<b>Docket Number:</b>	22-BSTD-04
<b>Project Title:</b>	2022 Energy Code Photovoltaic and Battery Storage Cost Effectiveness Determinations
<b>TN #:</b>	254847
<b>Document Title:</b>	Powertree Services Inc Comments - Benjamin Apartments can be cost Effective and then some
<b>Description:</b>	N/A
<b>Filer:</b>	System
<b>Organization:</b>	Powertree Services Inc.
<b>Submitter Role:</b>	Other Interested Person
<b>Submission Date:</b>	3/5/2024 12:50:33 PM
<b>Docketed Date:</b>	3/5/2024

**Benjamin Apartments can be cost Effective and then some**

**Powertree Comments re Analysis and Cost effectiveness of Benjamin Apartments Cost Effectiveness**  
**March 5, 2024**                      **CEC Docket: 22-BSTD-04**

Here is an example SLD of a Meter Adapter installation of a Powertree system:

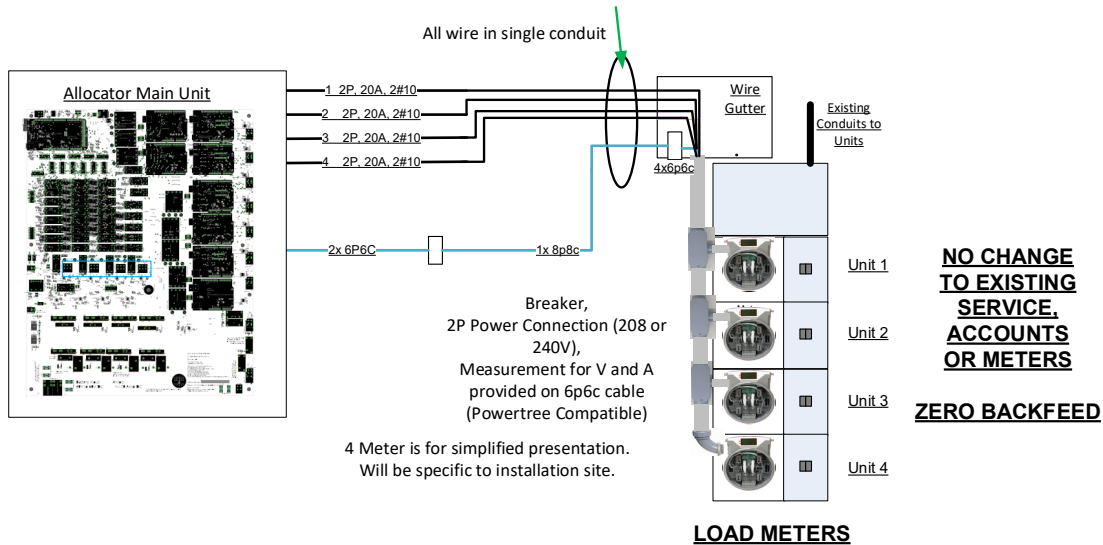
5. Wall mount disconnects and subpanels are not the only way for solar to be connected to a Tenant or recipient meter and should not be the assumption for cost estimations.

As in any application the appropriate technology needs to be used. Multi-Family presents some unique needs in their design. For example, DC Coupled systems feeding the Solar PV into a battery can have a single disconnect for the Battery and flexibility for the AC connection.

Use of Meter Socket adapters with or without Microgrid capabilities is currently approved or being approved by the IOUs and are directly transferable to non-IOU installations. [UL 414 SB approved] The meter socket adapters are safer than standard sockets as they cool the meter more and they integrate the disconnect AND V & A measurement directly into the adapter. ***Adapters take less than 30 minutes***

***to install and require NO additional wall space and lead to MUCH lower installation cost per meter.***
